STAFF REPORT
COMMUNITY DEVELOPMENT DEPARTMENT

HEARING DATE: 06/16/2026
TO: Mayor & City Council
FROM: Sonya Allen, Associate Planner
sallen@meridiancity.org
SUBJECT: Dayspring Subdivision No. 2
FP-2026-0004
LOCATION: Generally located off the southeast corner of the N. McDermott Road bypass and W. Ustick Rd., in the NW 1/4 of Section 4, T.3N., R.1W.

Final plat consisting of 41 buildable lots and 12 common lots on 17.88 acres of land in the R-4, R-8 and TN-R zoning districts for the second phase of Dayspring Subdivision.

DAYSPRING SUBDIVISION NO. 2

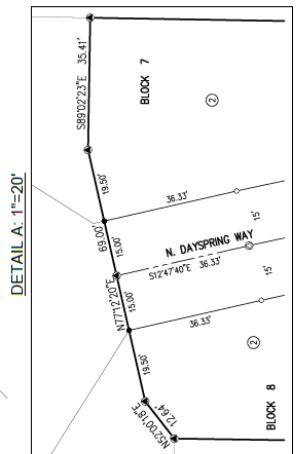
3. Prior to submittal for the City Engineer's signature, have the Certificate of Owners and the accompanying acknowledgement signed and notarized.
4. The final plat prepared by Clinton W. Hansen, Land Solutions Land Surveying and Consulting, dated: 2/10/2026, included in Section V.B shall be revised as follows:

- a. Include the Book and Page numbers for Dayspring Subdivision No. 1.
 - b. Legend: Include the recorded instrument number of the ACHD permanent easement.

- c. Include the recorded instrument number of the ACHD drainage easement.
 - d. Include the recorded instrument number of the City of Meridian sewer easement.

- e. Note #9: Include the recorded instrument number for the development agreement (i.e. #2026-007562).
 - f. Note #11: Include the recorded instrument number of the ACHD temporary license agreement.

A copy of the revised plat shall be submitted with the final plat mylar signature application.

C. Landscape Plan (dated: 2/9/2026)

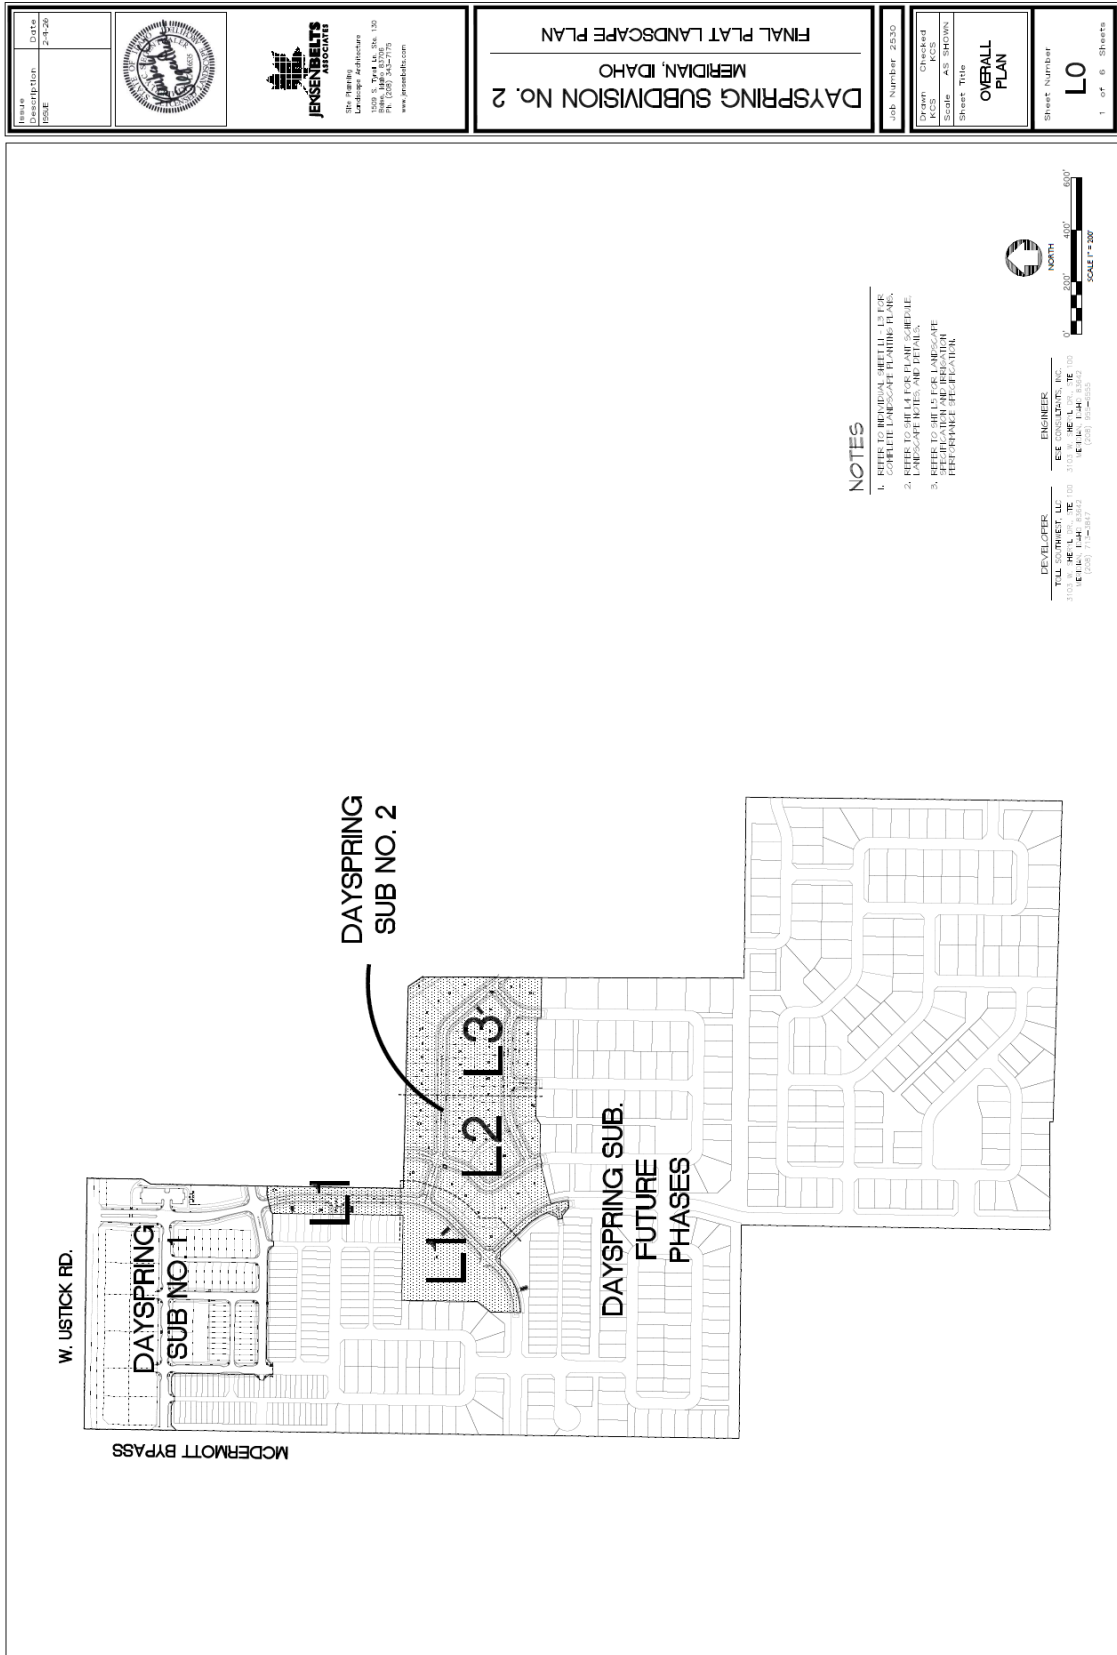
5. The landscape plan prepared by Jensen Belts Associates, dated 2/9/2026, included in Section V.C, shall be revised as follows:
 - i. All pathways and associated landscaping shall be located outside of irrigation district easements unless permission is specifically obtained from the governing Irrigation District. If permission cannot be obtained, adjustments shall be made to the plat to provide these improvements outside of the easement.

- ii. Depict landscaping in all street buffers in accord with the standards listed in UDC 11-3B-7C, which requires landscape areas to be designed and planted with a *variety* of trees, shrubs, lawn or other vegetative groundcover that elicit design principles including rhythm, repetition, balance and focal elements.

- iii. Depict minimum 5-foot wide landscape strips along each side of all pathways with landscaping per the standards in UDC 11-3B-12C, which require a *mix* of trees, shrubs, lawn and/or other vegetative groundcover.

- iv. Depict landscaping in common open space areas per the standards listed in UDC 11-3G-5B.3, which require a minimum of one (1) deciduous shade tree for every 5,000 sq. ft. of area and include a variety of trees, shrubs, lawn or other vegetative groundcover. Include calculations that demonstrate compliance with this standard.

- v. Include the required vs. proposed number of street trees in the Landscape Calculations table for the street buffer along N. Dayspring Way that demonstrates compliance with the standards listed in UDC 11-3B-7C.3.

- vi. Include the required vs. proposed width of the street buffer along N. Dayspring Ave. in the Landscape Calculations table.
- vii. Include the required vs. proposed number of trees along pathways, including linear feet of pathways, in the Landscape Calculations table that demonstrates compliance with the standards listed in UDC 11-3B-12C.

A copy of the revised landscape plan shall be submitted with the final plat mylar signature application.

D. Amenity Exhibit for Lot 1, Block 9

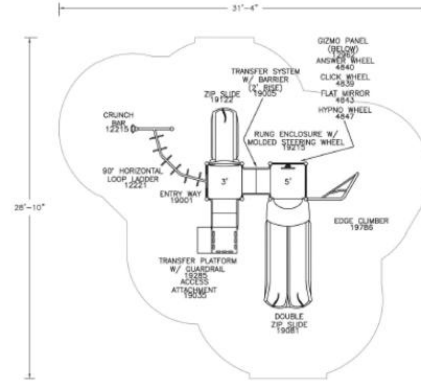
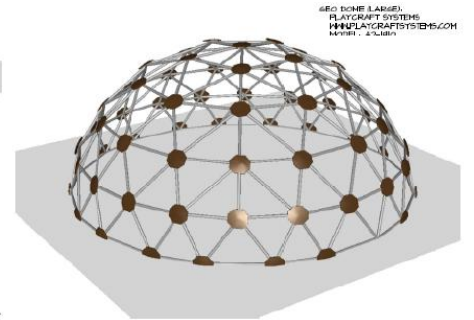
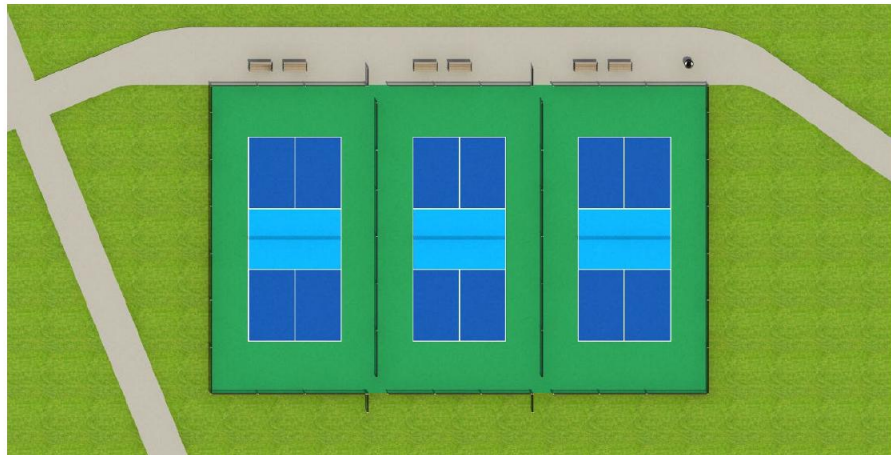
- 10. A Certificate of Zoning Compliance and Administrative Design Review applications shall be submitted for the clubhouse, swimming pool, sports courts, picnic area with shelter and playground and common area landscaping on Lot 1, Block 9. Landscaping shall be required in accord with the standards listed in UDC 11-3G-5B. These improvements shall be completed prior to issuance of the first Certificate of Occupancy in this phase of development.
